SERVICE BULLETIN

MODEL NAME : Di620
MODEL CODE : 1155
NO. : 033A
DATE : 990518
SUBJECT : PRINTING SPEED INCREASED

To increase the printing speed if the Di620 is used as a printer, the following modifications have been implemented.

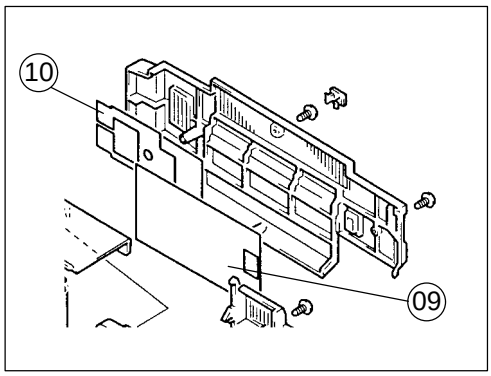
1. The software program of the following ICs (01 to 07) has been changed.

2. The software program of IC70B on P. W. Board-B has been changed. Due to this, the memory program of the memory card IC (08) has been changed.

IC70 Version : 10G044-00 ➡ 10H001-00

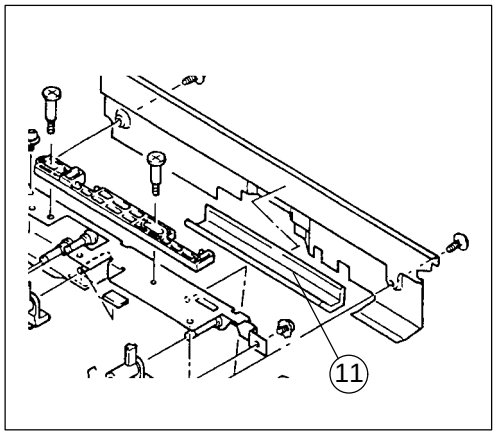
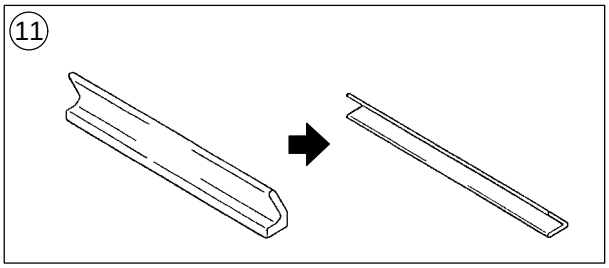
3. The mats (09, 10) for shielding have been discontinued.

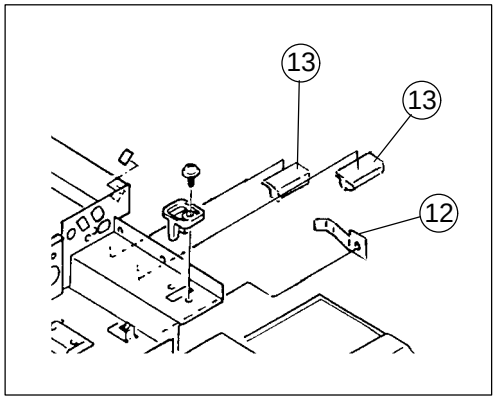
4. The shape of the shield (11) in the manual bypass section has been changed.

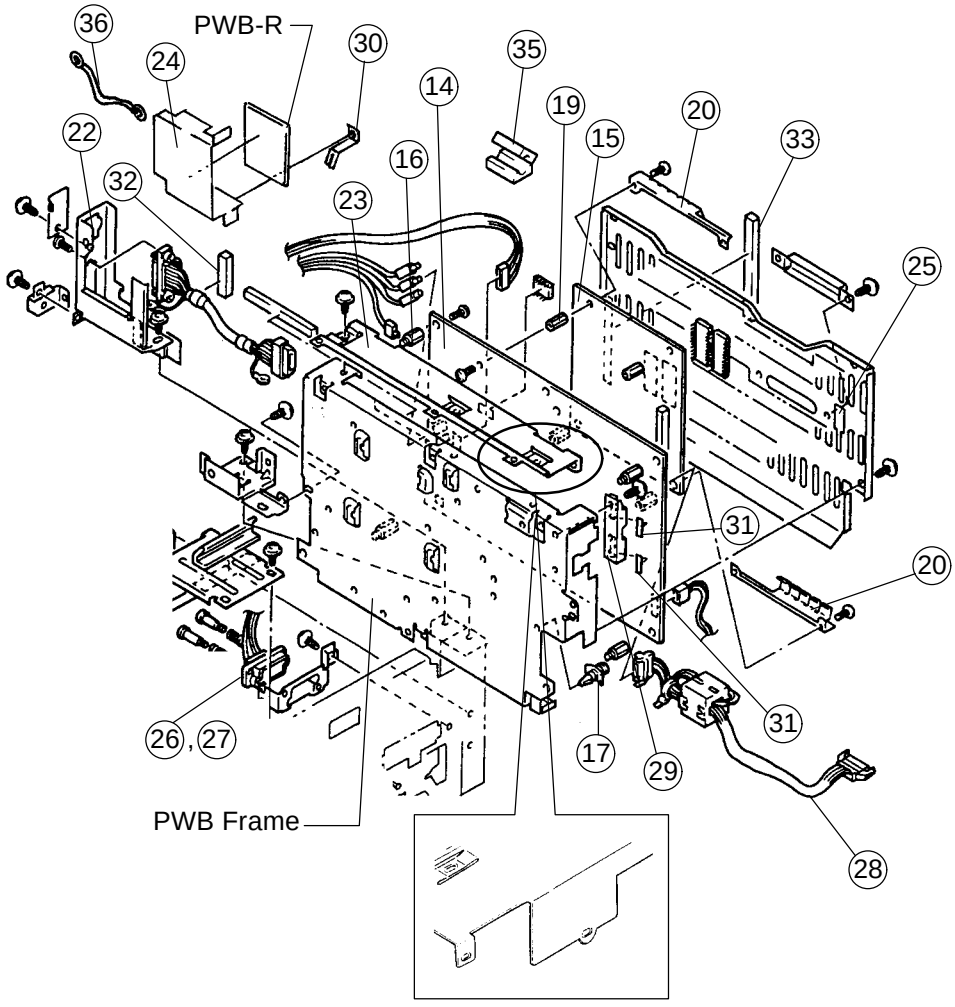
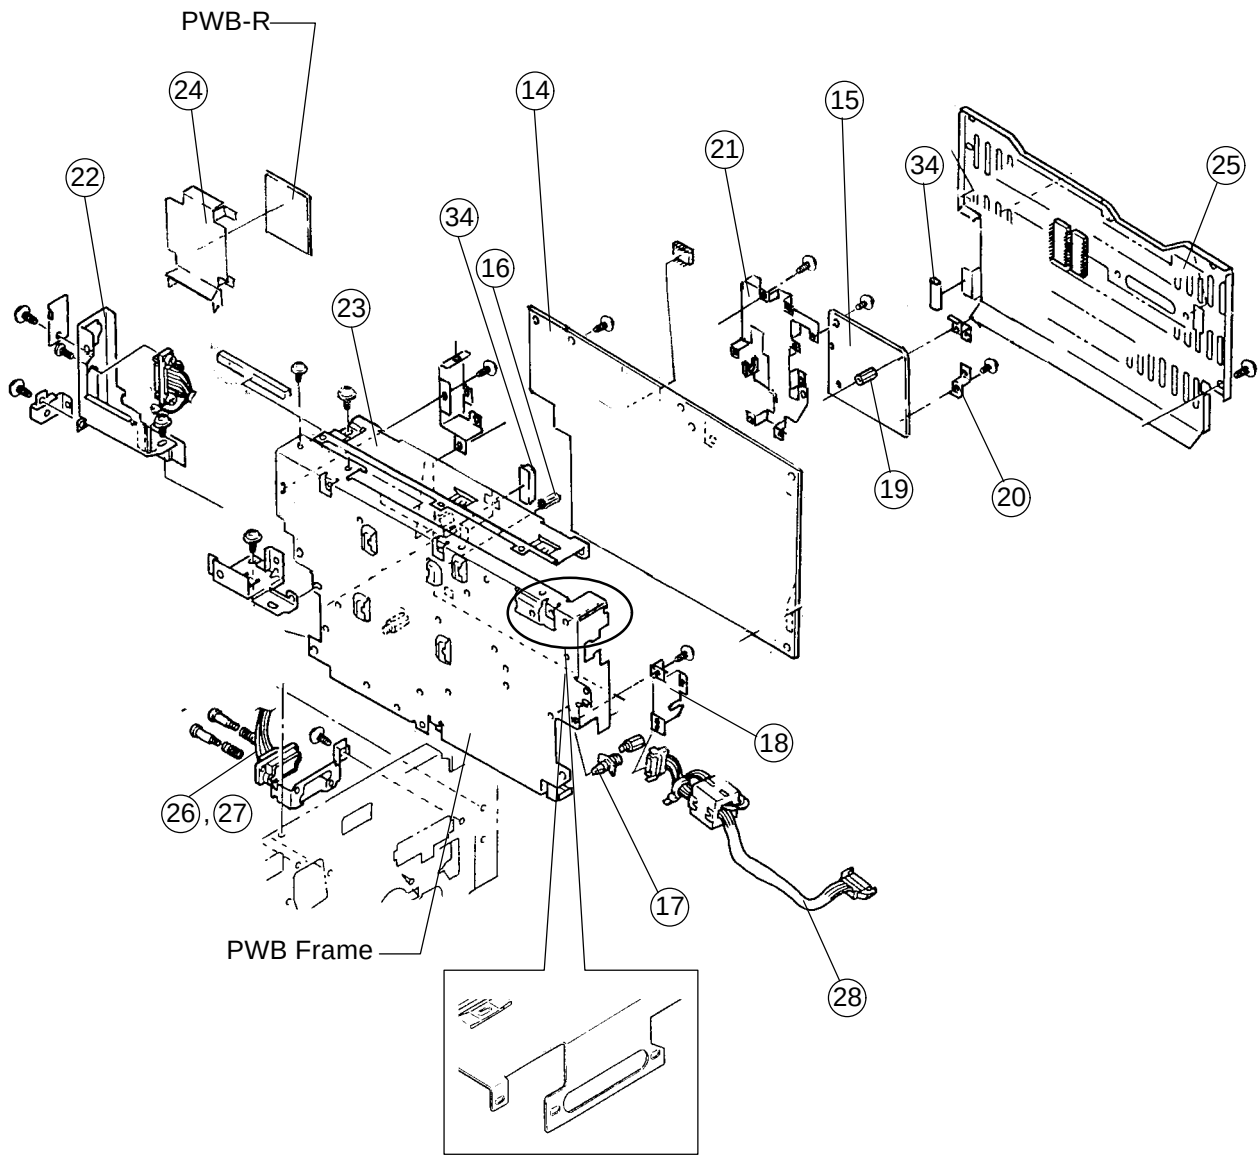
5. A plate spring (12) for grounding and shields (13) have been added in the duplex unit.

6. Some electrical parts have been added on P. W. Board-B (14) and P. W. Board-W (15).
7. The number of PWB supports (16) for PWB-B have been decreased by two. The number of other PWB supports (17) have been decreased by six and bracket (18) have been added instead.

8. The number of PWB supports (19) for PWB-W have been decreased by two. Instead, the shape of the bracket (20) for PWB-W has been changed and a bracket (21) has been added.

9. The shape of the PWB frame, connector bracket (22), brackets (23, 24) and PWB cover (25) has been changed.
10. The ferrite cores have been discontinued from the harnesses (26 to 28).

11. The plate spring (29, 30) for grounding, seal (31) and shields (32, 33) have been discontinued.
12. A shield (34) has been added.
13. The ferrite core (35) has been discontinued.

14. The grounding wire (36) is not necessary due to the PWB-B change. Therefore, the wire (36) has been discontinued.

1155A002AB

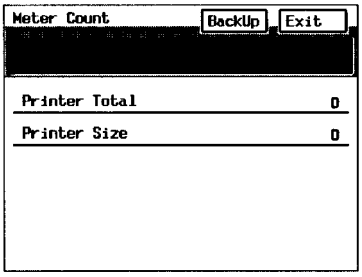
(2) Two new counters have been added to Meter Count.

- Printer Total
- Printer size

1155A015AB

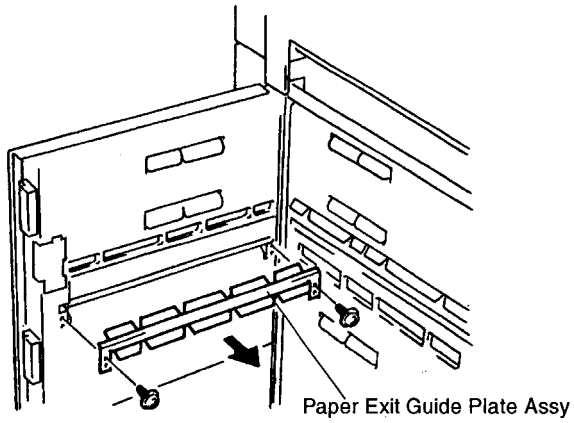
(3) New PM items have been added.

- Replacement of the Paper Exit Guide Plate Assy
  1155-0755-01

Di520	Di620
1280K	1200K

- Removal of the Paper Exit Guide Plate Assy

1155A003AB

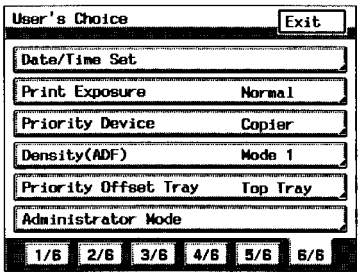
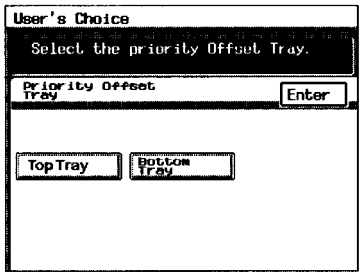
1. Priority Offset Tray has been added to p. 6/6.

- When the copier is equipped with an FN-3, the priority offset tray is to be selected, either the Top Tray (Non-Sort Tray) or Bottom Tray (Elevator Tray).
- If Top Tray is selected and its capacity is reached while a copy/print cycle is being run, the Bottom Tray (Elevator Tray) is automatically selected to accommodate the subsequent sheets of paper.
- Setting options (the default setting is highlighted):

1155A005AB

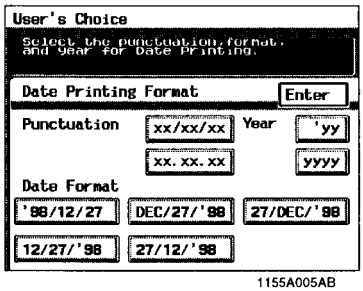
2. Date Printing Format has been added to p. 3/6.

- The number of digits for the year can now be selected, either 2 or 4 digits.

1155A006AB

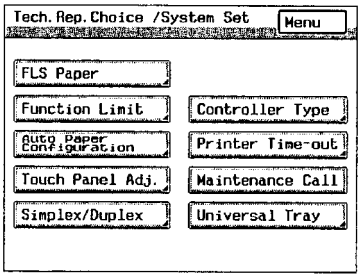
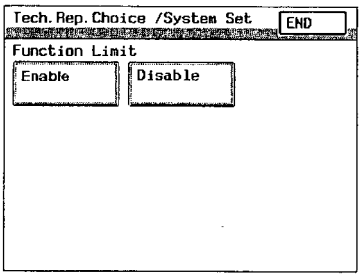
1. "Function Limit" and "Controller Type" have been added to System Set of Tech. Rep. Choice.

- If "Enable" is selected for "Function Limit," these are the functions that can be set on the control panel: Paper, Zoom, Density, the number of copies to be made, Mixed Orig. Detection, Free Orig. Placement, or Small Orig. Adjustment of Original.
- Setting options (the default setting is highlighted):

1155A008AB

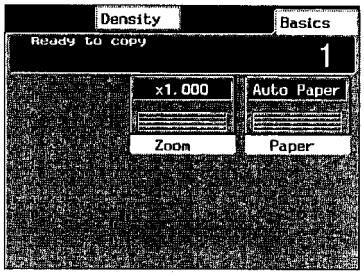
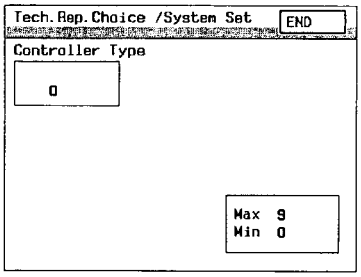
- Controller Type should be set to "0."
- Setting options (the default setting is highlighted):

1155A010AB

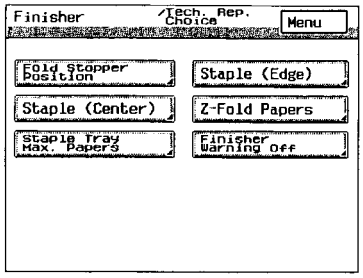
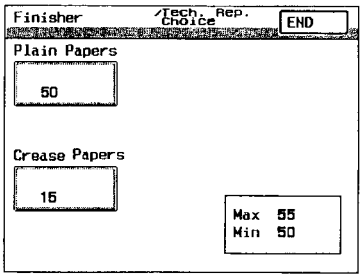
2. "Staple Tray Max. Papers" has been added to "Finisher" under Tech. Rep. Mode.
- If a value exceeding the default of 50 is set, it could lead to a misfeed or a defective Stapler. The Tech. Rep. should therefore explain in detail to the users.
- Setting options (the default setting is highlighted):

- If any number between 15 and 20 is set for Crease Papers, the number of copies to be made in non-crease, center staple is also restricted to the range of 15 to 20.
- Setting options (the default setting is highlighted):

1155A014AB

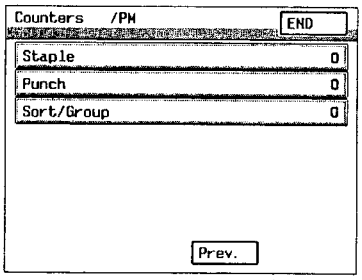
3. Items have been added to PM Counters
- Items: Staple, Punch, Sort/Group

1155A012AB

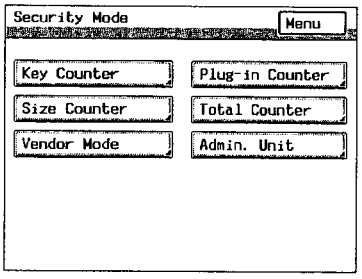
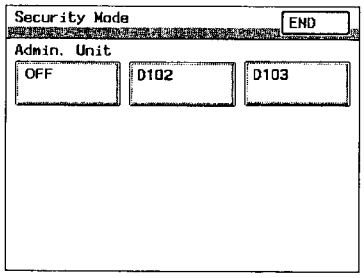
- "Admin. Unit" has been added.
- Setting options (the default setting is highlighted):
